**NOVEMBER 8, 2023
REPLACEMENT OF BRIDGE NO. 07001
MICHAEL'S WAY OVER WEST BRANCH SAUGATUCK RIVER
TOWN OF WESTON, CT
FEDERAL PROJECT NO. 6157(012)
STATE PROJECT NO. 0157-0088**

ADDENDUM NO. 03 SUMMARY

1. Revised bid opening date to November 15, 2023, 2:00 pm.
2. Revisions resultant from questions received through 11/7/2023.

PROJECT NUMBER: 0157-0088
 PROJECT DESCRIPTION: REPLACEMENT OF BRIDGE NO. 07001 MICHAEL'S WAY OVER WEST BRANCH SAUGATUCK RIVER
 TOWN(S): WESTON
 DRAWING TITLE: GENERAL PLAN AND ELEVATION
 DRAWING NO. S-02
 SHEET NO. 04.02.A3

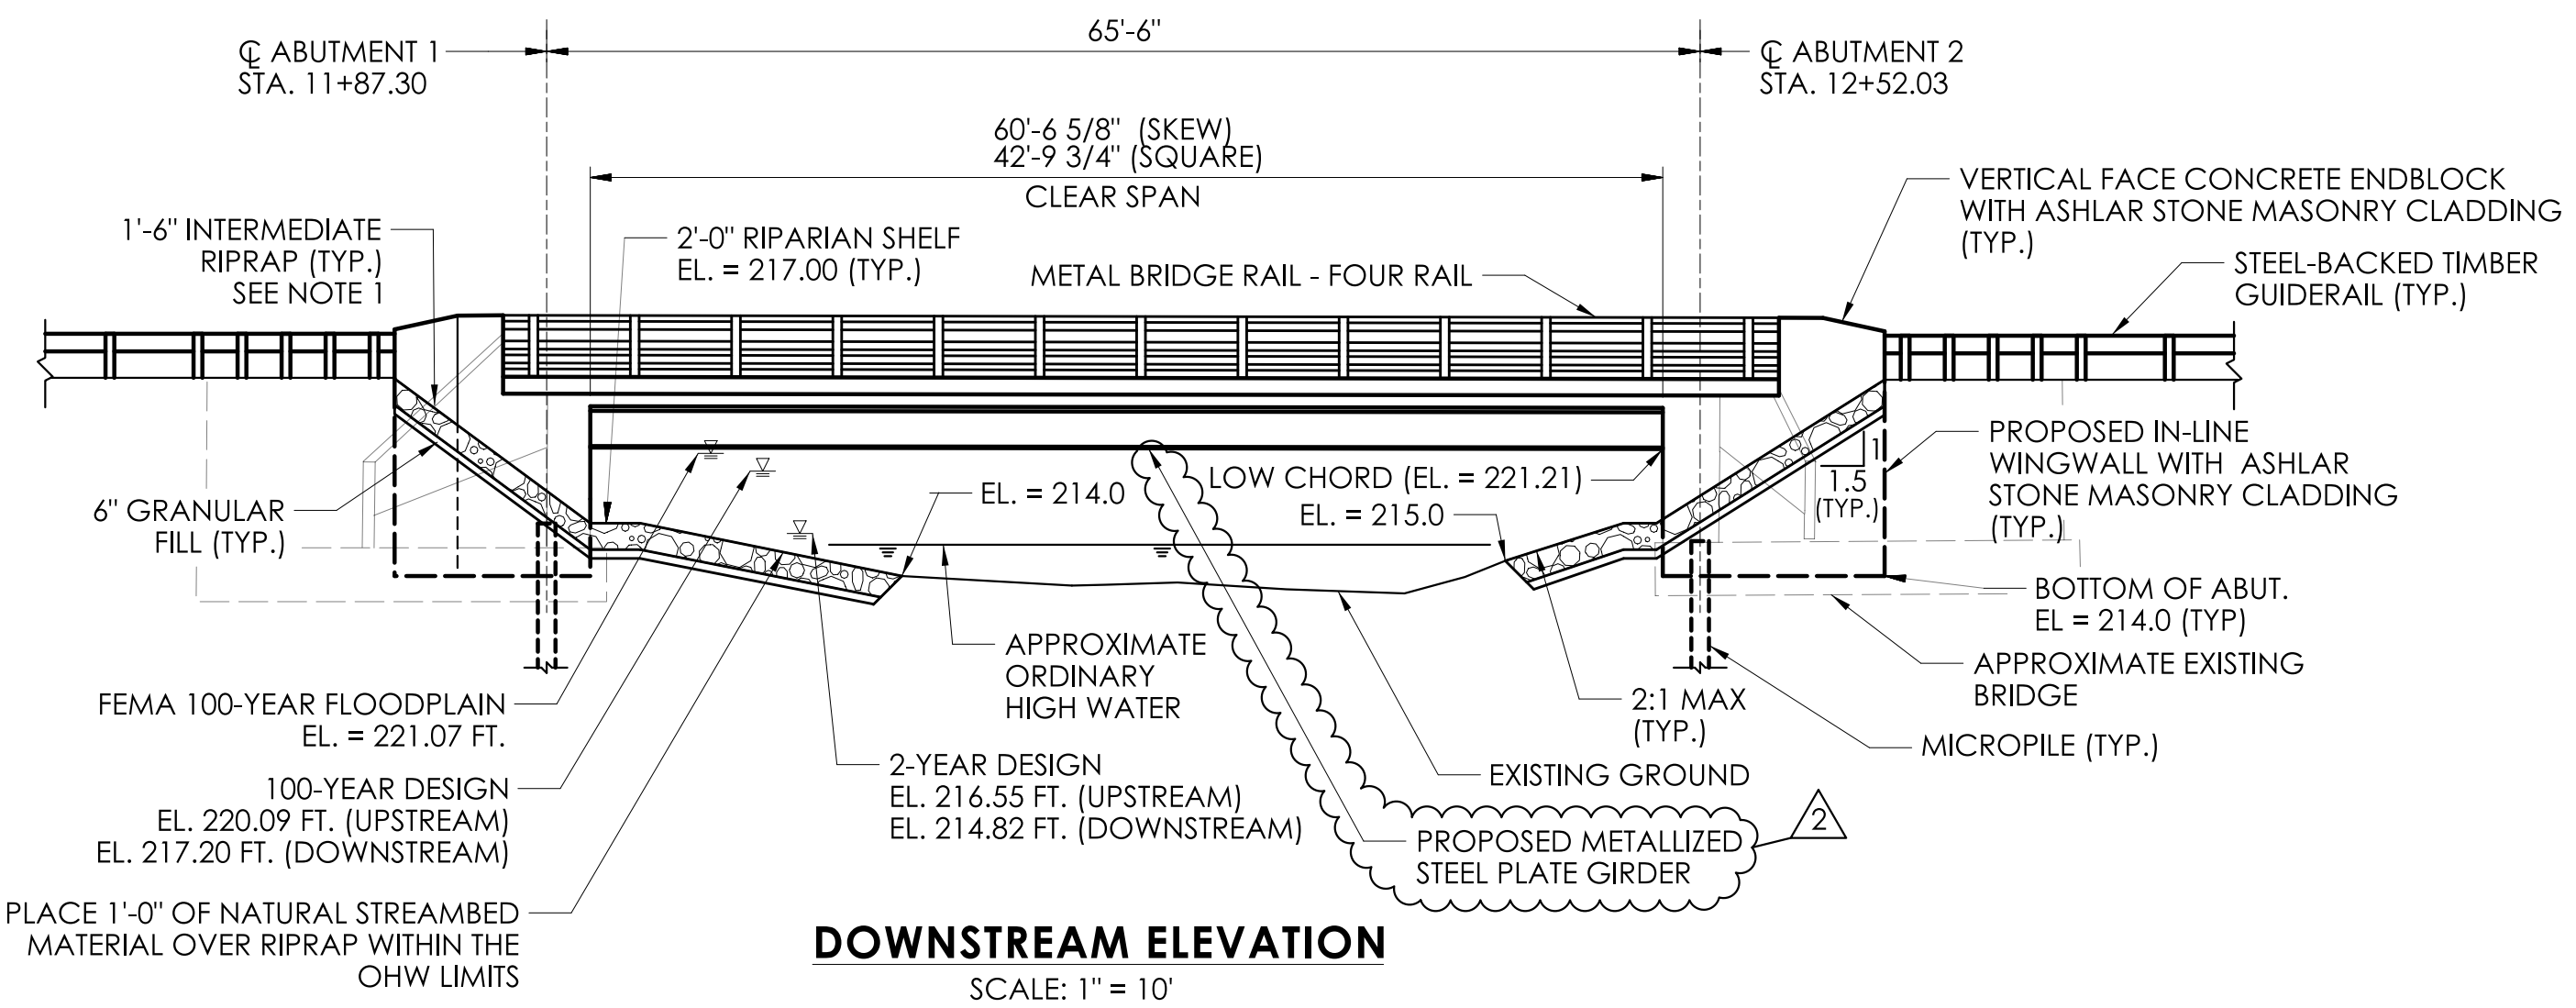
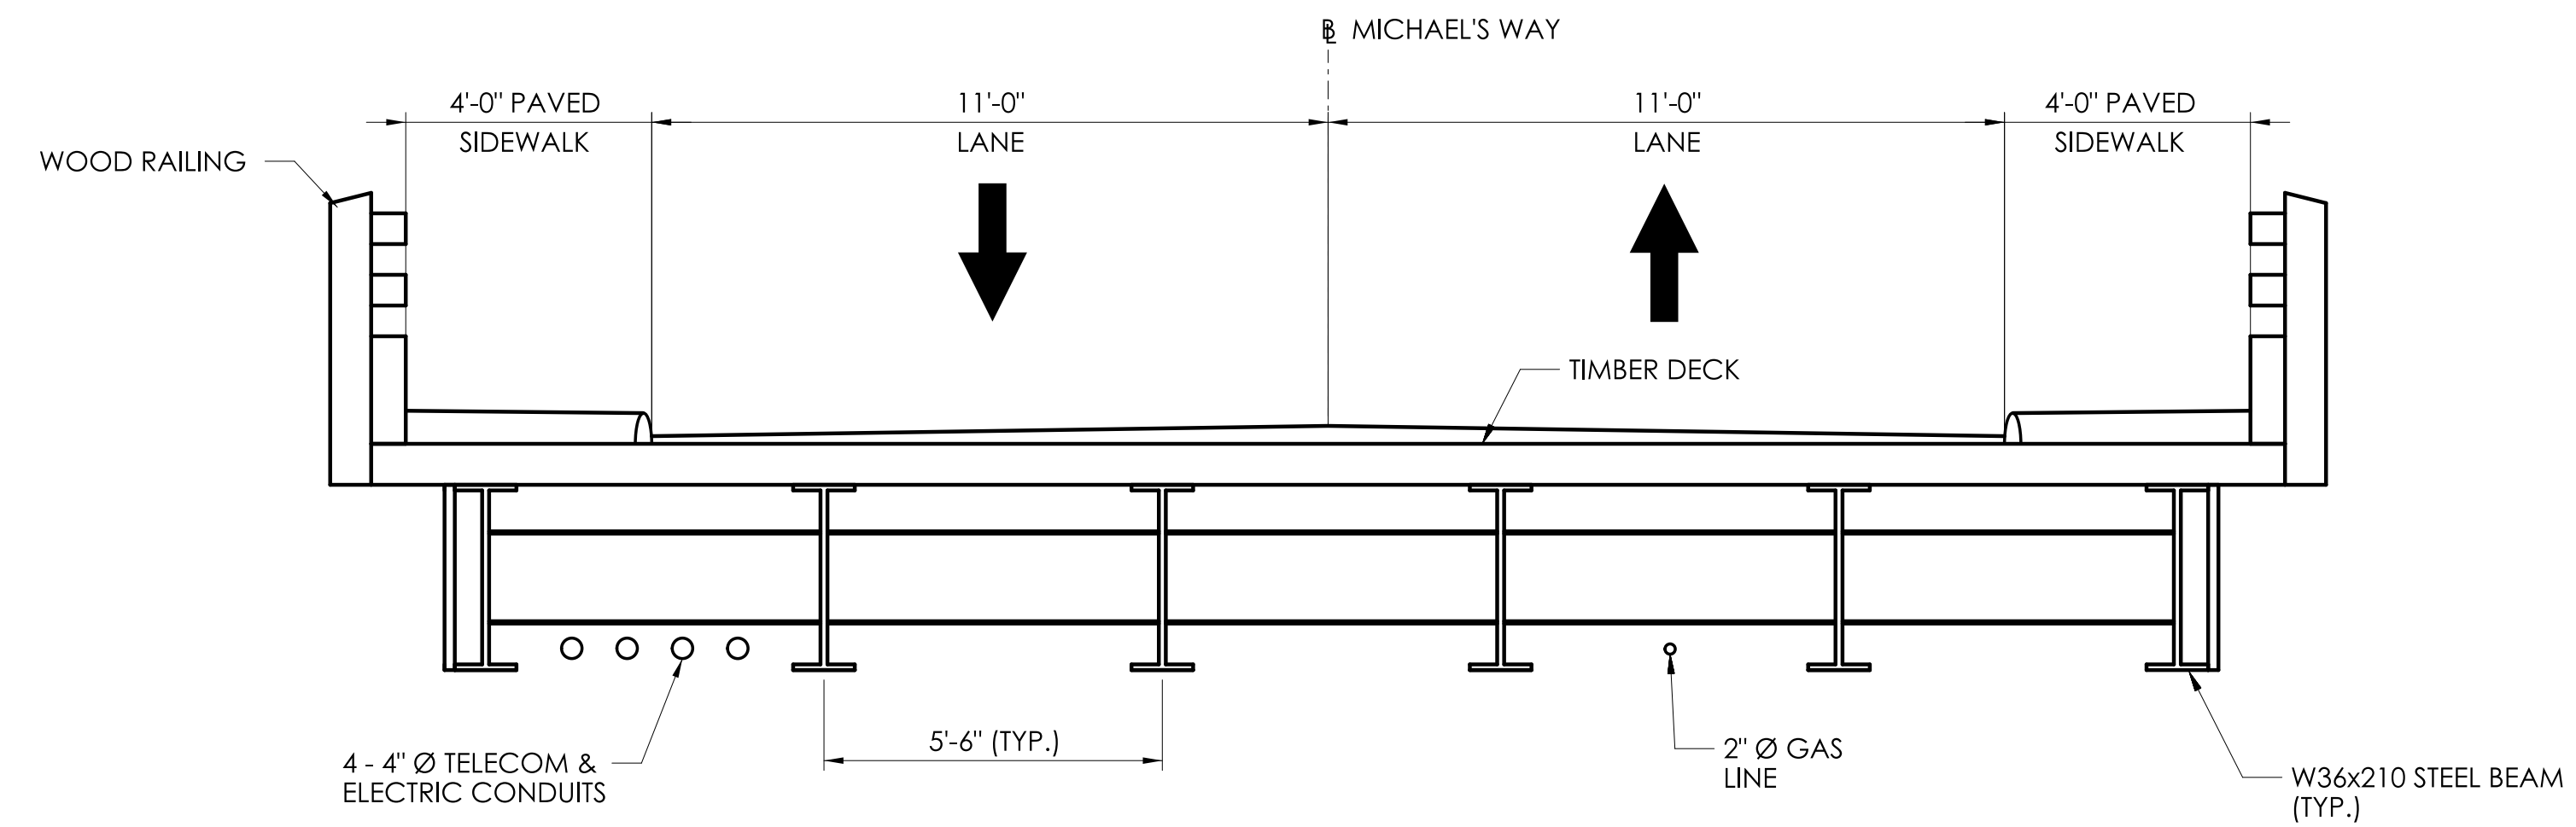
REV.	DATE	DESCRIPTION
1	11/03/23	CORRE METALLIZING REVISION
2	10/24/23	GAS LINE REVISION

DRAWING NO. S-03
 SHEET NO. 04.03.A3

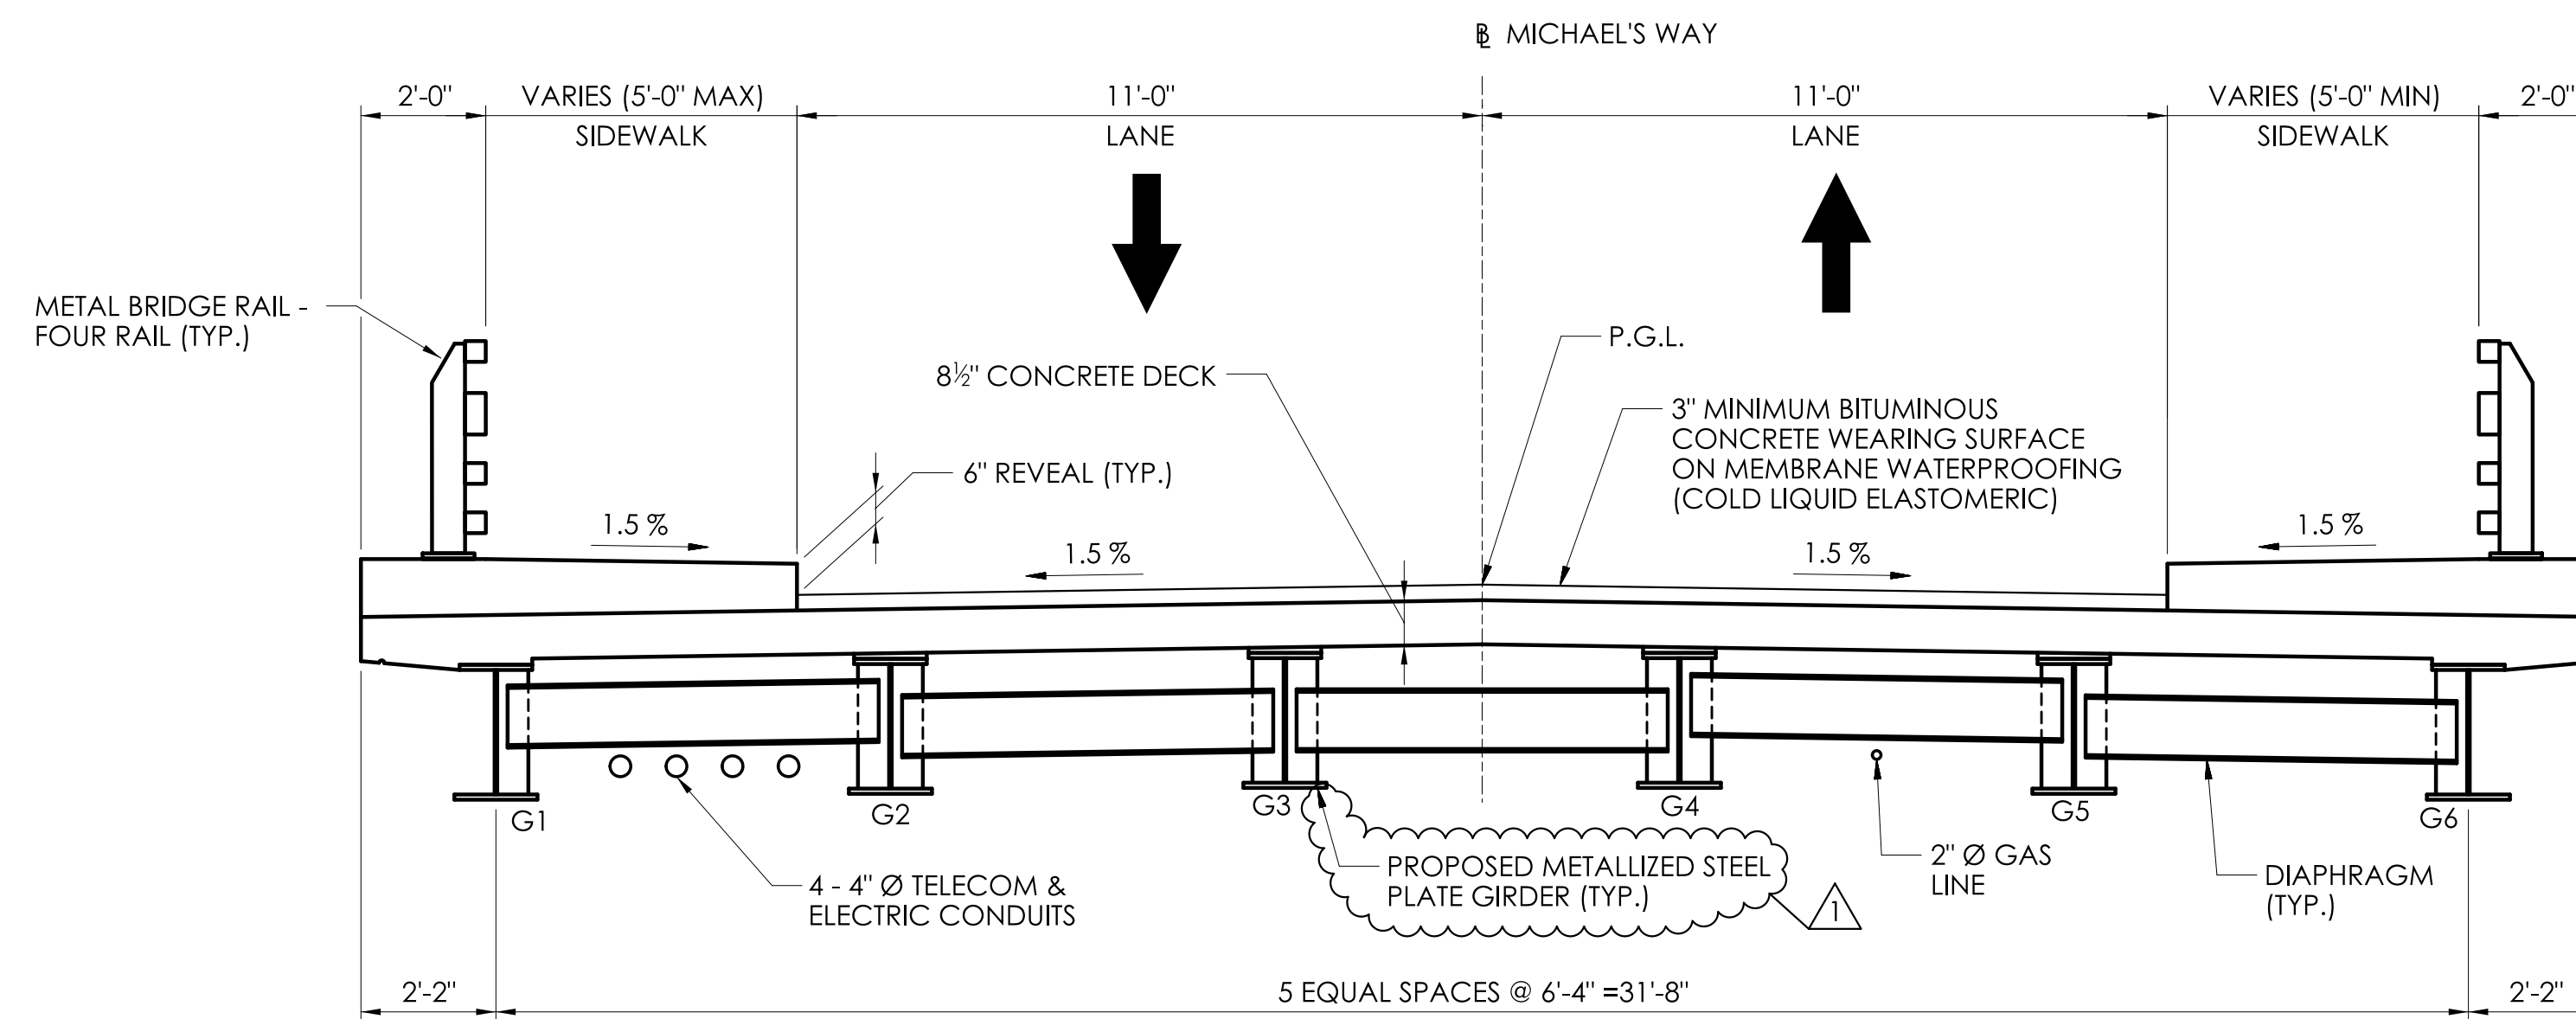
REV.	DATE	DESCRIPTION
1	11/03/23	GIRDER METALLIZING REVISION

PROJECT NUMBER: 0157-0088
 PROJECT DESCRIPTION: REPLACEMENT OF BRIDGE NO. 07001 MICHAEL'S WAY OVER WEST BRANCH SAUGATUCK RIVER
 TOWN(S): WESTON
 DRAWING TITLE: FRAMING PLAN AND DETAILS

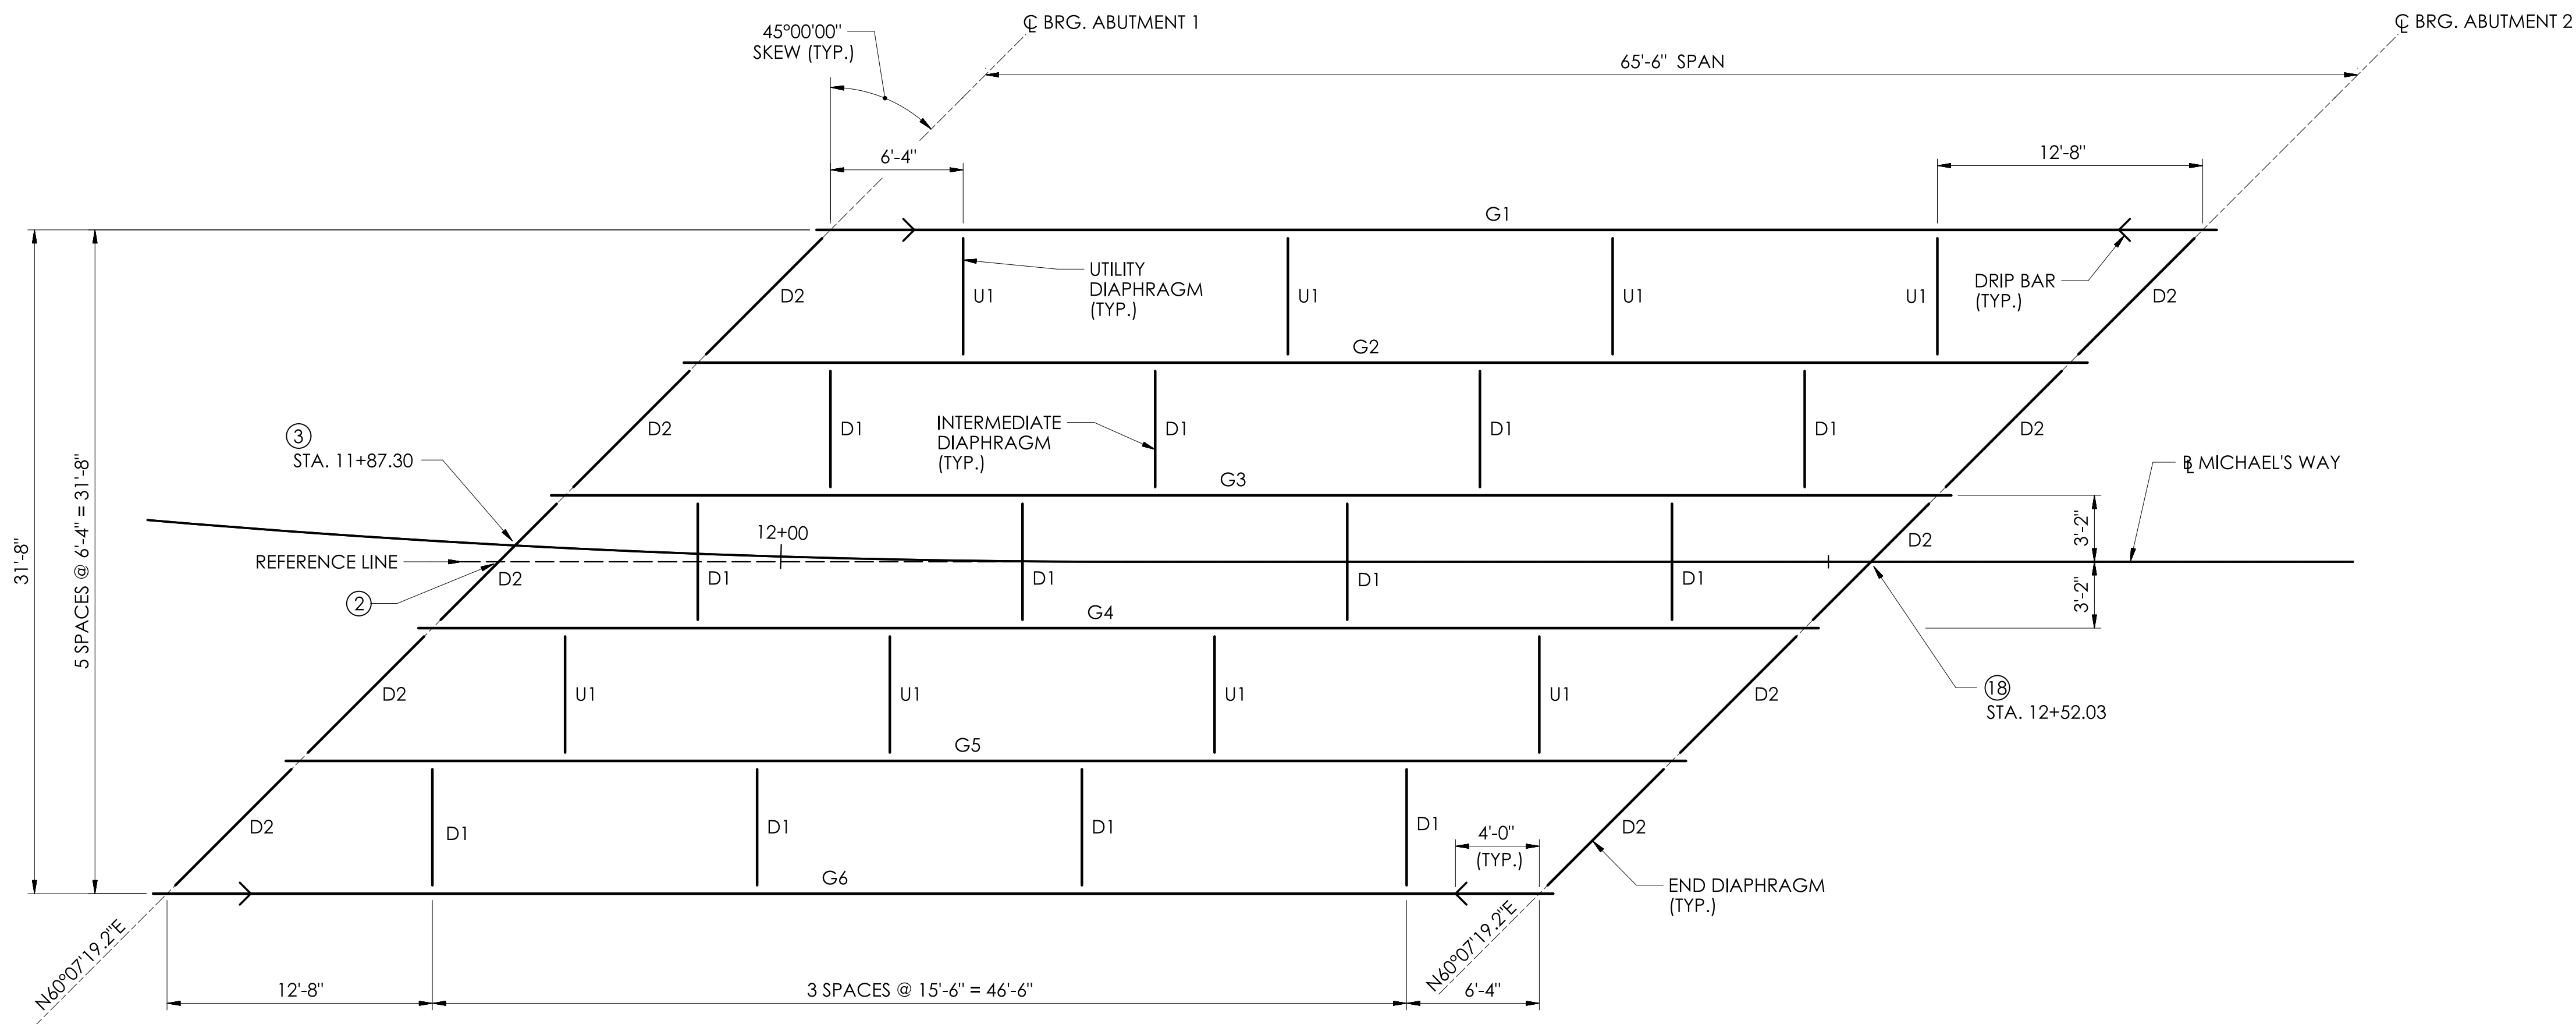
REV.	DATE	DESCRIPTION
1	11/03/23	GIRDER METALLIZING REVISION
2		REVISION DESCRIPTION

- ALL STRUCTURAL STEEL (LOW ALLOY) SHALL CONFORM TO AASHTO M270 GRADE 50 T2 AND SHALL BE METALLIZED.
- WELDING DETAILS, PROCEDURES AND TESTING METHODS SHALL CONFORM TO THE LATEST ANSI/AASHTO/AWS D1.5 - BRIDGE WELDING CODE, UNLESS OTHERWISE NOTED ON THE PLANS.
